MONTGOMERY COUNTY HISTORIC PRESERVATION COMMISSION
STAFF REPORT

Address:	6 Hesketh St., Chevy Chase	Meeting Date:	2/7/2018
Resource:	Outstanding Resource Chevy Chase Village Historic District	Report Date:	1/31/2018
Applicant:	John and Vicky Duff (Jennifer Kirwan, Architect)	Public Notice:	1/24/2018
Review:	HAWP	Tax Credit:	N/A
Case Number:	35/13-18F	Staff:	Michael Kyne
PROPOSAL:	Fenestration alterations

PROPOSAL

PROPOSED WEST ELEVATION

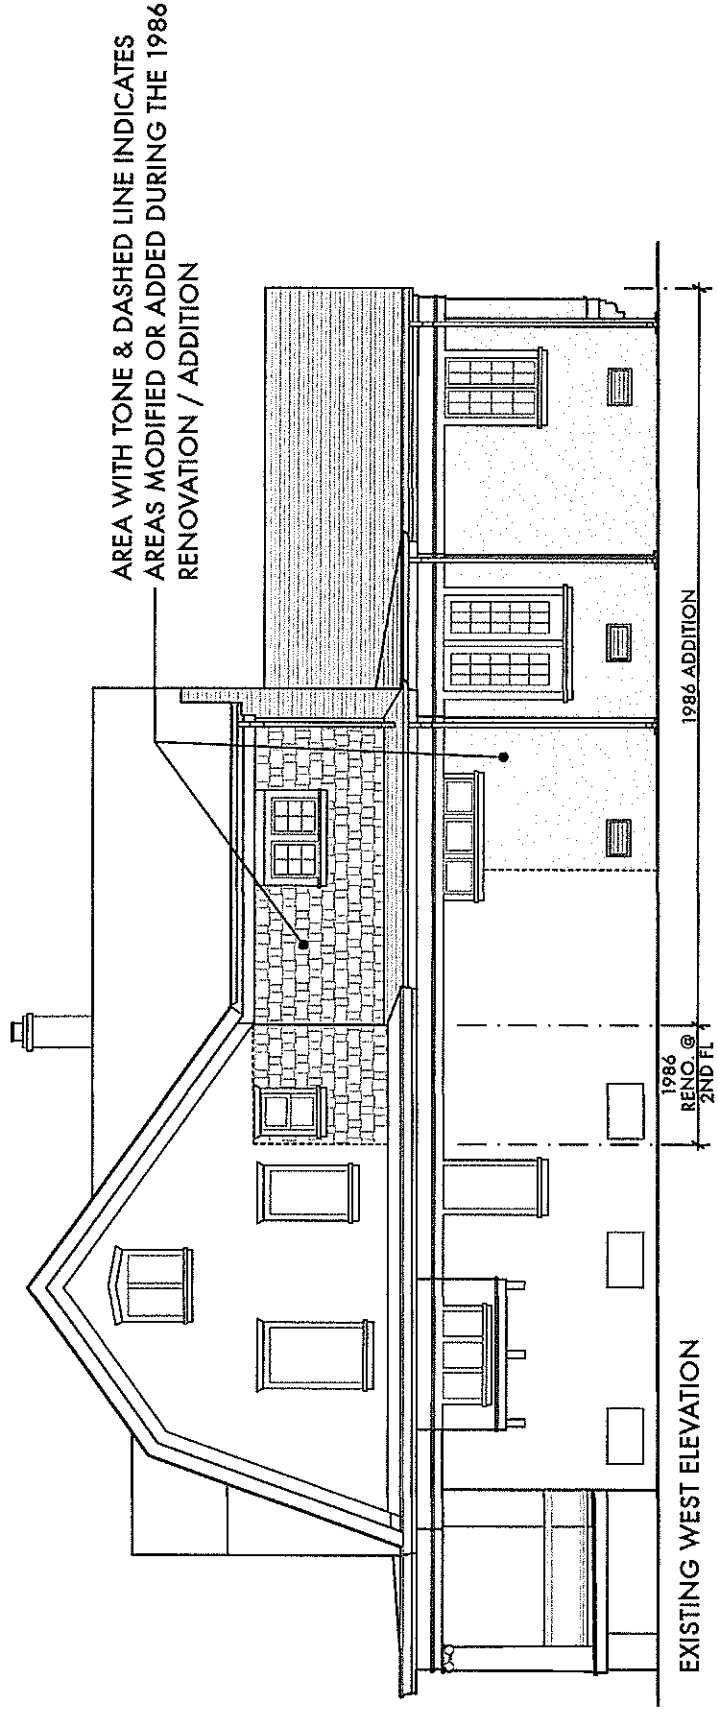
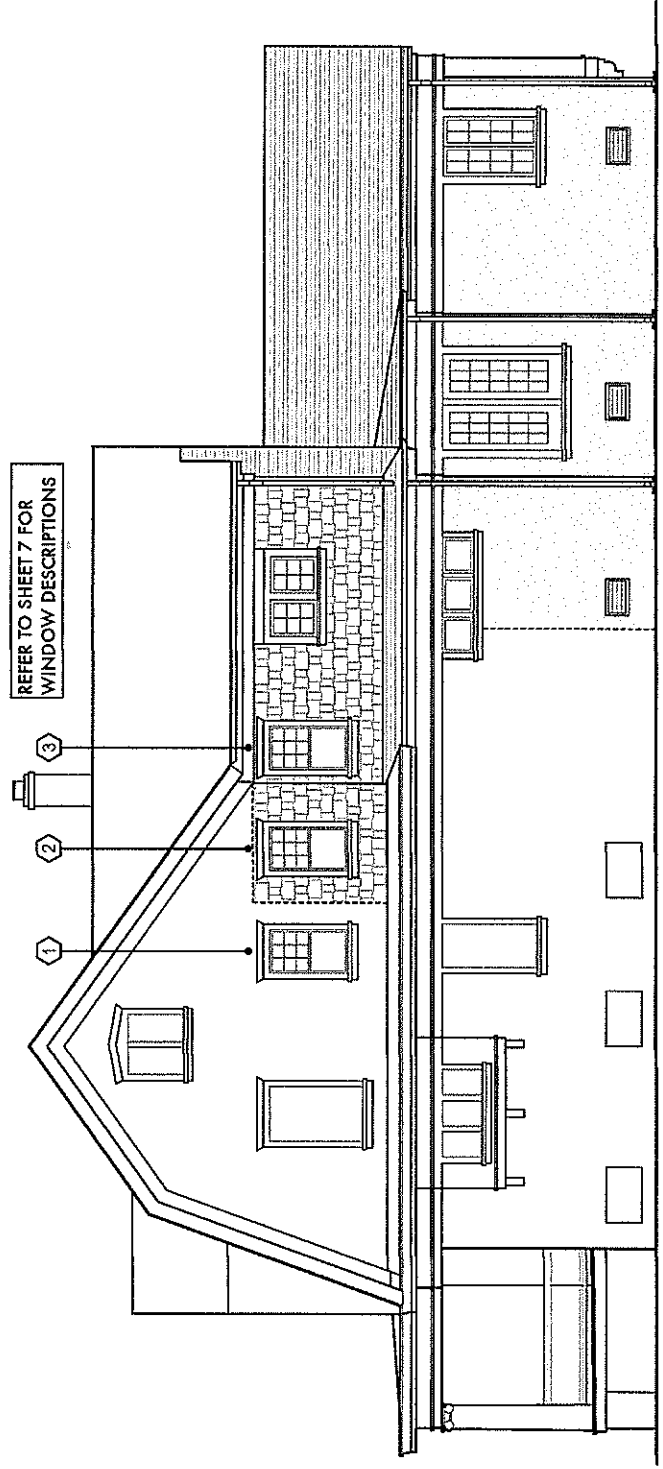
The applicants propose to replace one non-original 1-over-1 window on the left elevation of the historic house (rearmost window on the second-floor) with a new 9-over-1 wood SDL window to closely match the original windows. The window to be replaced is in a wall plane of the historic house that experienced previous alterations when a rear addition was constructed in 1986. The proposed replacement window is larger than the existing window, and the existing non-original window opening will have to be enlarged to accommodate the new window; however, staff is not concerned about a potential loss of original materials, due to the aforementioned alterations. The proposed replacement window is compatible with the historic house and will not detract from the character-defining features of the subject property or surrounding streetscape.

The applicants propose to install one new window on the second-floor of the left elevation of an existing 1986 rear addition. The proposed new window will be a 9-over-1 wood SDL window to closely match the original windows of the historic house. The proposed new window is compatible with the historic house and will not detract from the character-defining features of the subject property or surrounding streetscape.

EXTERIOR MUNTIN PROFILE FOR
WINDOWS '2' & '3', SELECTED TO MATCH
TYPICAL WINDOW @ EXISTING RESIDENCE.

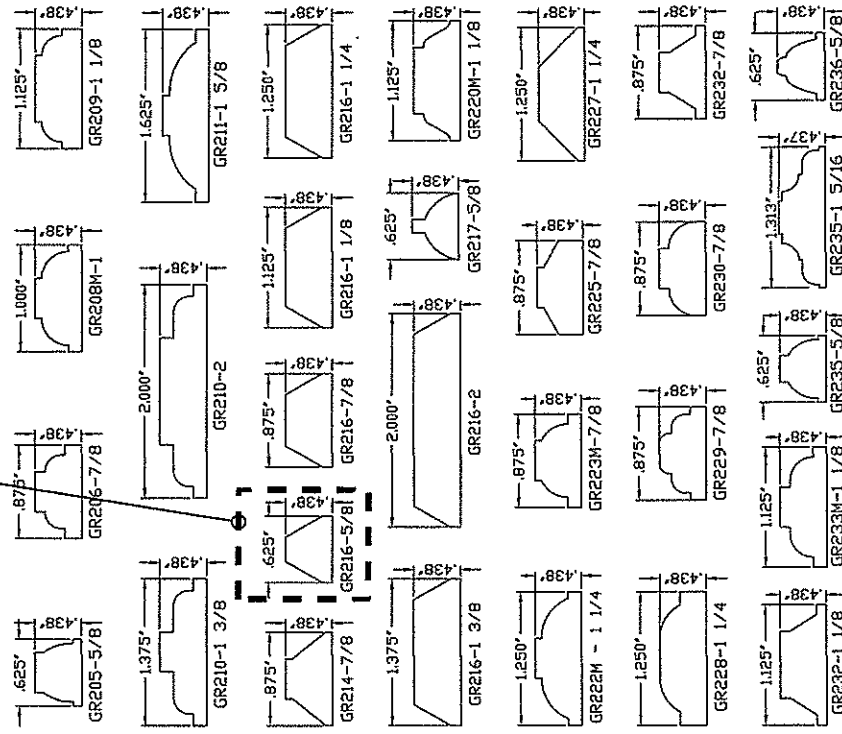
The application states that the proposed new windows will have 5/8" profile muntins to closely match the original windows of the historic house; however, while the submitted specifications indicate that the proposed windows are available with a variety of muntin/grille options, the applicants have not clearly

- 1. The proposed new windows will have permanently affixed muntins and spacer bars.**

indicated which options they are proposing. In accordance with preservation best practices and the HPC's typical requirements for new SDL windows, staff recommends that the HPC approve the applicants' proposal, with the condition that the proposed new windows will have permanently affixed muntins and spacer bars.

WINDOW '1': HISTORIC WINDOW (VIEW FROM INTERIOR)
 PROPOSED WORK: RE-GLAZE EXISTING WINDOW AND REPLACE
 WITH NEW SINGLE PANE LAMINATED OBSCURED GLASS; NO
 OTHER ALTERATION OF WINDOW IS PROPOSED.

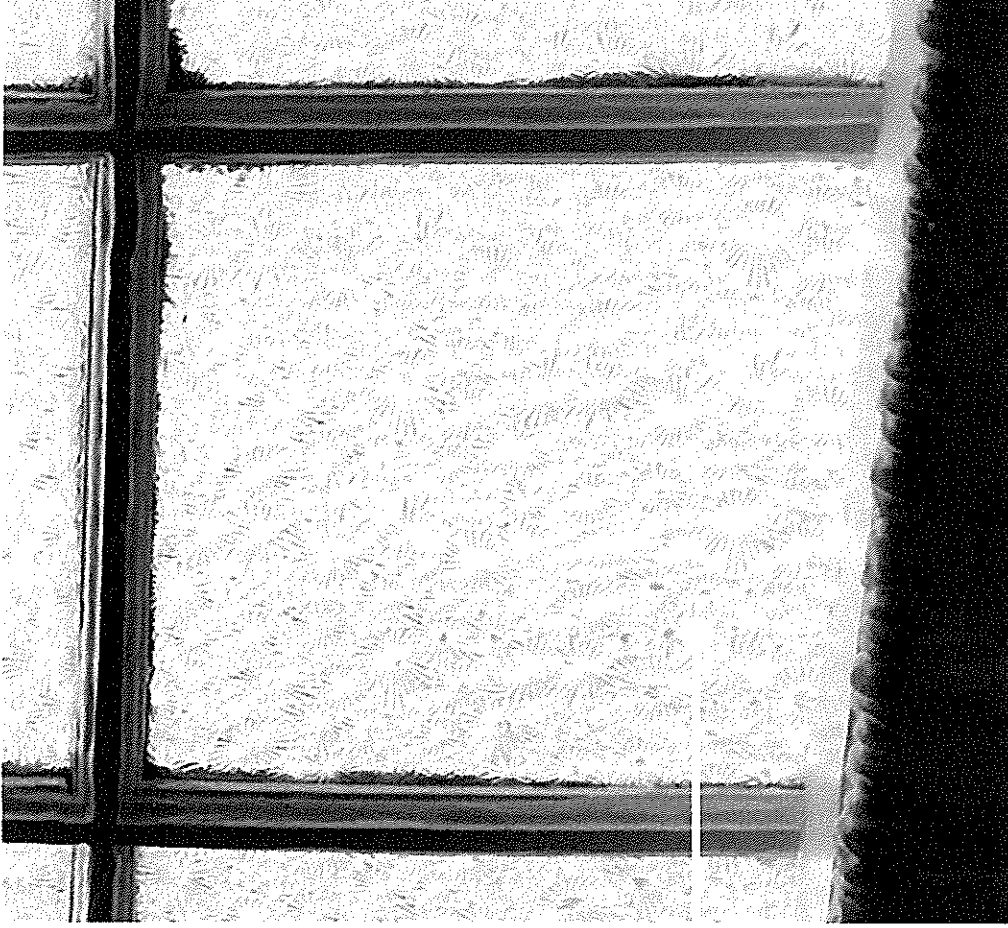
The applicants propose to reglaze and replace the glass of one original 9-over-1 window on the left elevation of the historic house. Although the window is original, the glass in it is not. The existing glass is obscured glass and the replacement glass will be similar. The proposed window reglazing and glass replacement is considered routine maintenance and is not subject to review by the HPC.
